A/YL-SK/435

再次提議渠務報告 (Proposed)

事項: 回復 2026-02-26 信函 Comment

RE Proposed drainage plan

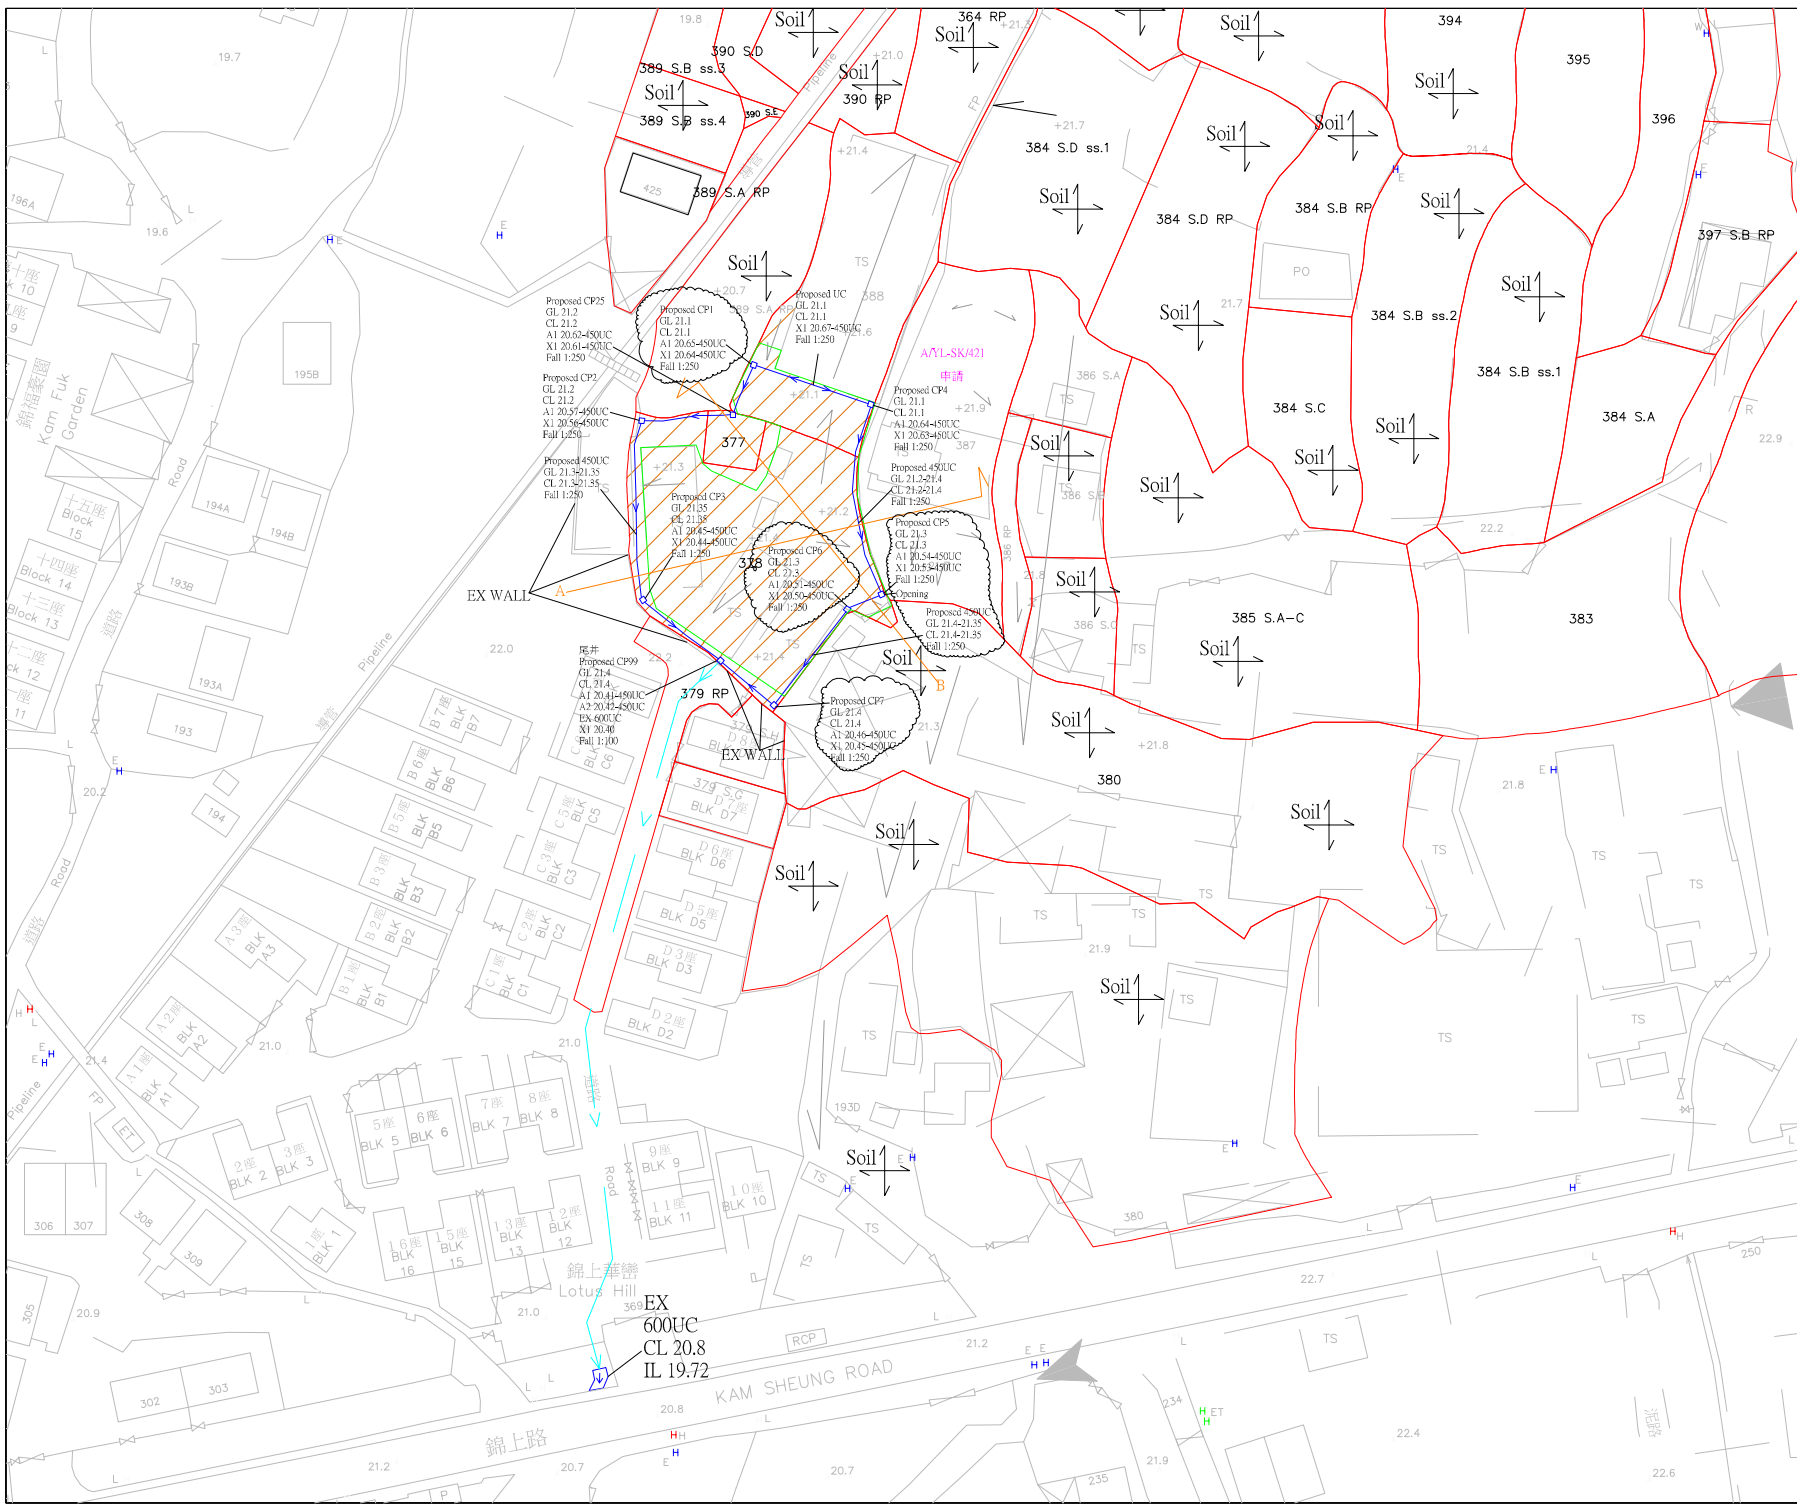
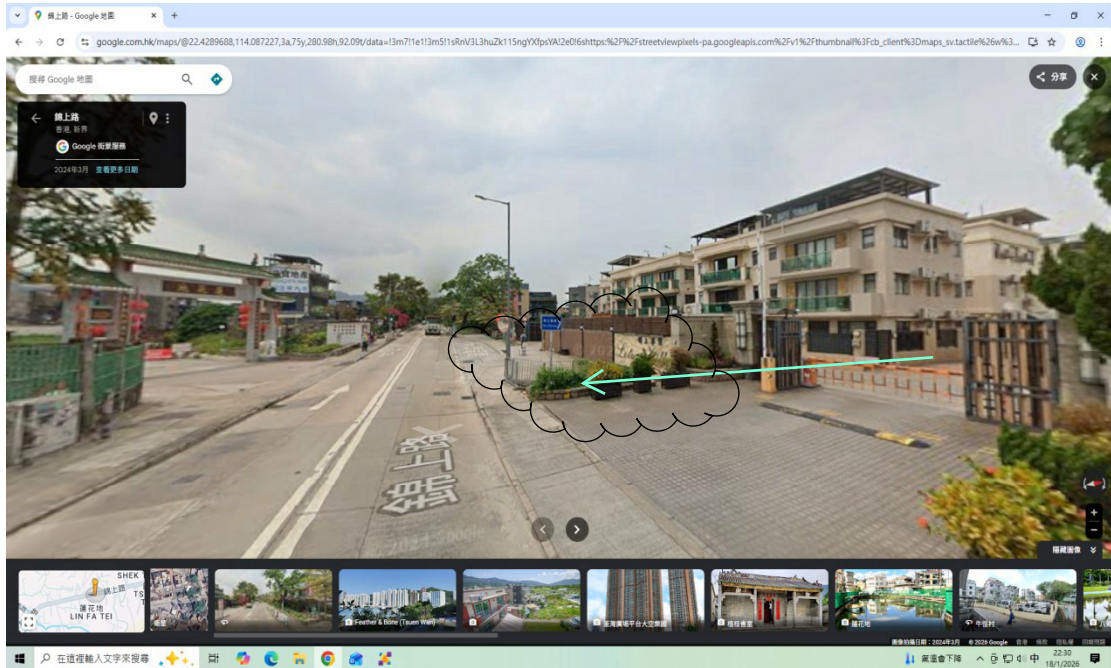
簡介	
2026-02-26 Comments	回復
i) Since the proposed drainage system from CP5 to CP99 will collect both the surface runoff from the application sites (A/YL-SK/435 and A/YL-SK/421) and the overland flow from adjacent site. Please consider upgrade the size and/or gradient of these proposed drainage facilities accordingly.	在b2-3 中已經修改 & e1-3 e2-3 e3-3中示
ii) Please review the gradient of the proposed 400mm u-channel (from CPI to CP25) is 1:25 or not. Please note that the hydraulic capacity of the downstream drainage facilities should not be smaller than the upstream ones. Please review.	在b2-3 中已經修改
iii) The submitted site photos cannot indicate and show the current conditions of the existing 600UC. Please provide more site photos at different views and locations for review.	因是私人地段和有高圍牆, 管理員不給予進入, 只能在出口有相片, 管理人員口頭說出要在政府有關官員作出申請進入, 其餘外來人士不得進入私人地方. (c3-3 & c4-3)
iv) The existing 600mm u-channel, to which the applicant proposed to discharge the stormwater from the subject site was not maintained by this office. The applicant(s) shall resolve any conflict/disagreement arisen for discharging the runoff from the application site(s) to the proposed discharge point(s). In the case that it is a local village drains, DO/YL should be consulted. Moreover, the applicant(s) should ensure that this drainage system and the existing downstream drains/channels/streams have adequate capacity to convey the additional runoff from the application site(s). Regular maintenance should be carried out by the applicant(s) to avoid blockage of the system.	知道和明白

SK/435		Proposed 450UC	
L =	0.14465	Concrete	0.14465
H =	143.2	L =	143.2 m
A =	0.3	H =	0.3 m
	1368	A =	1368 m ²
		$t_0 =$	12.80 min

SK/435	&	SK/421
% =		0.219261
% =		0.085875
Q(m ³ /s) =		39.2 % OK

Drainage Impact assessment report of 450 mm channel is Acceptable
